SERVICE 		4
		X 87.123-26

MODEL 39 R

FUEL TANK

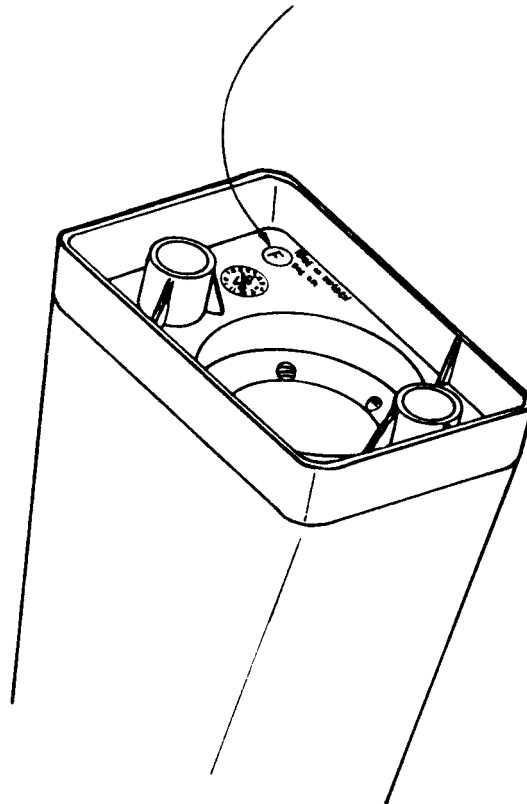
In order to avoid that radiation heat from the clutch warms up the fuel tank, the tank design is changed. The change means that a larger air gap is received between the fuel tank and the clutch.

A recess is introduced in the tank, at the same time. This is made in order to receive an easier assembly/disassembly of the cable unit.

The changed fuel tank is marked with "changing littera" F. It is fully interchangeable with older design.

The change is introduced from serial No 7471100.
